Service Bulletin

Subject: **Positive Battery Cable Routing**

Models Affected: Certain Collins Bus Diesel Models where no battery box is present.

Figure 1-B

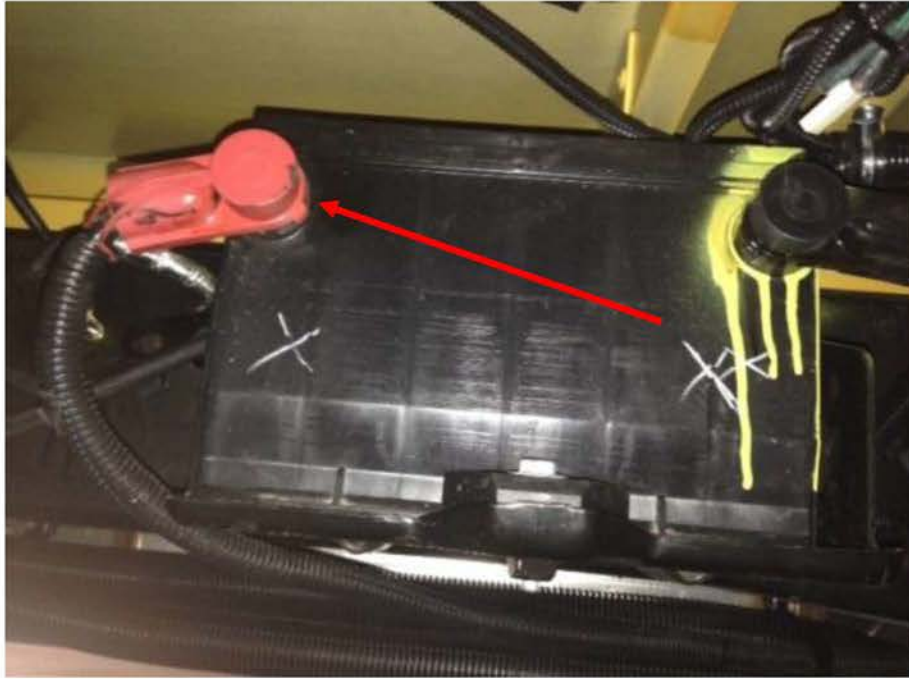
1. Begin by disconnecting the cable from the battery on RH frame rail.
(To avoid shock or spark, tape cable end to insulate)
Location: Passenger side behind entrance door mounted on frame rail.
See Figure 1-B

Figure 2-B

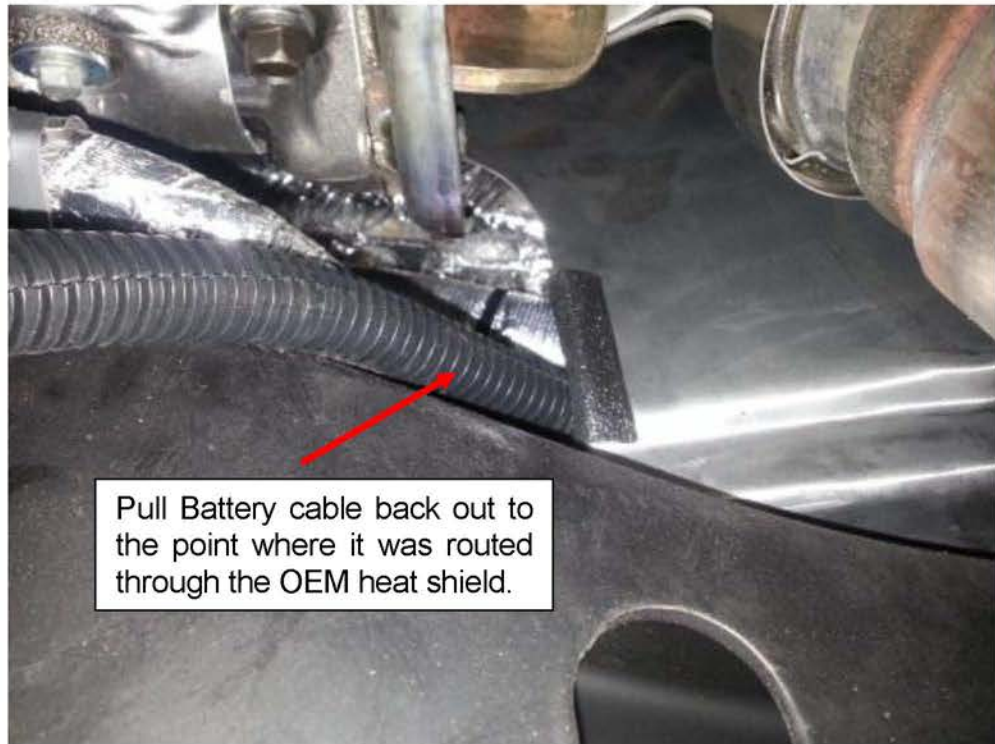
3. Pull the battery cable back out to the point where it was routed through the OEM heat shield.
See Figure 2-B
